Technical Service Information

THM 200C

SLOW TCC, TCC SHUDDER OR NO TCC

Figure 1

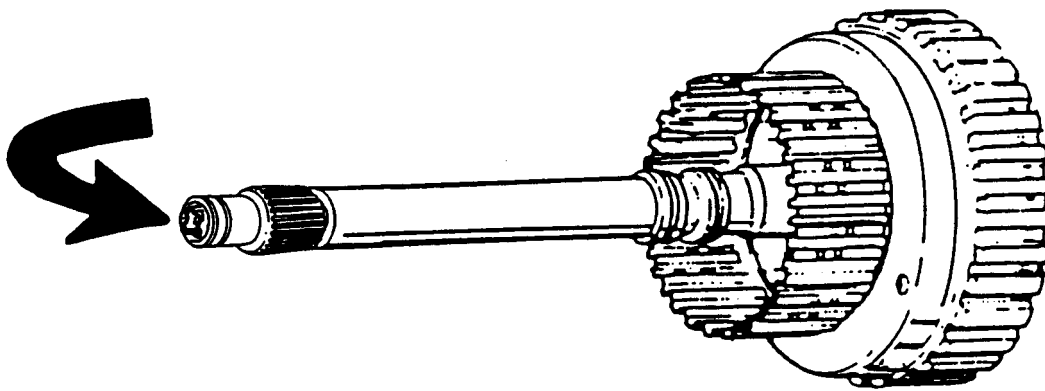
CAUSE: The plug, Item 222 (Figure 2) not having been removed from the pump stator support or cover. When the new turbine shaft with the ball capsule (Figure 1) was introduced in ,the 1987 models, October 8, 1986 (Julian Date 281), the cup plug should have been removed from the pump cover.

Figure 2

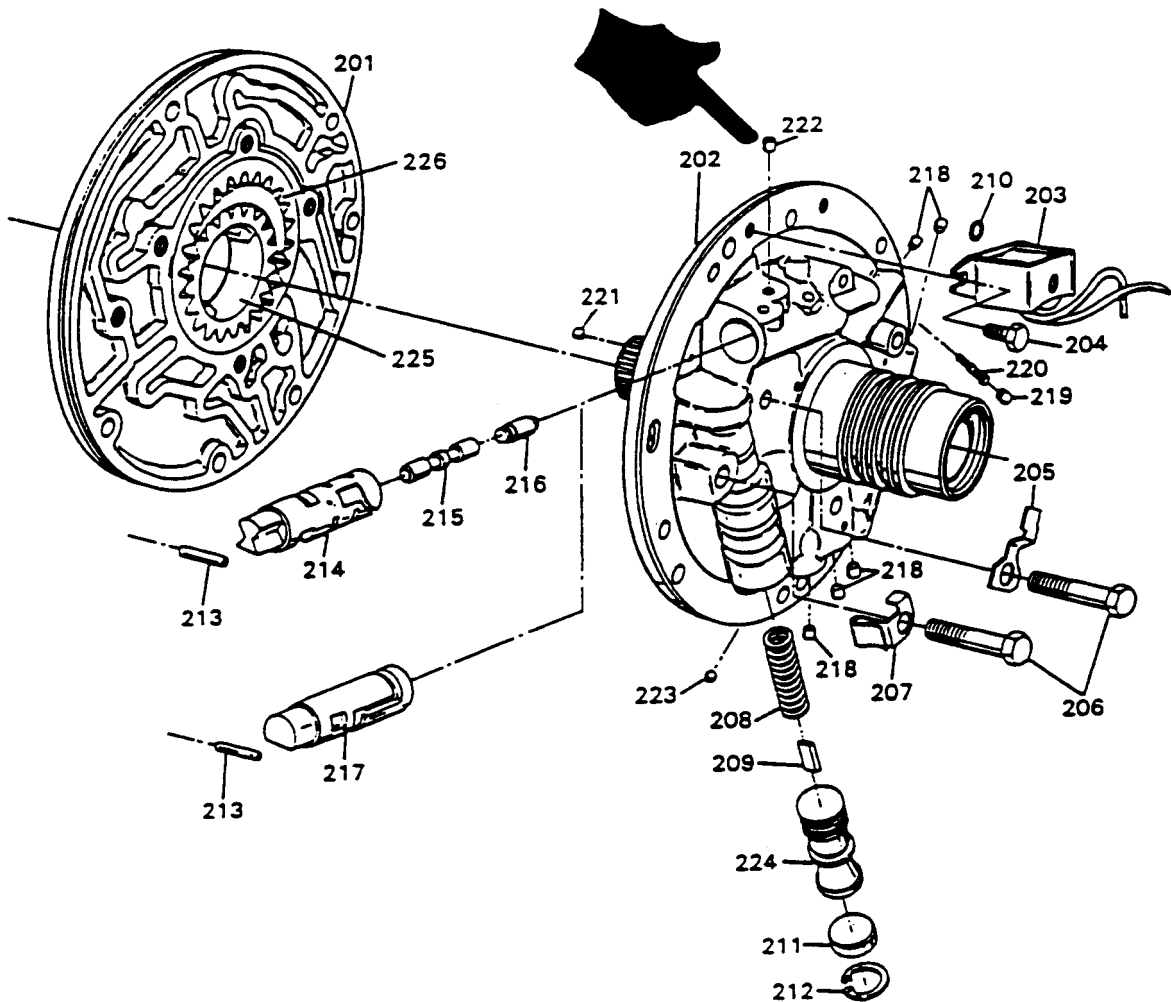
COMPLAINT: Slow converter clutch engagement, shudder or no engagement apply in all 1987 Vehicles equipped with a THM 200C transmission.

CORRECTION: Remove the cup plug, Item 222 (Figure 2) from the cover assembly..
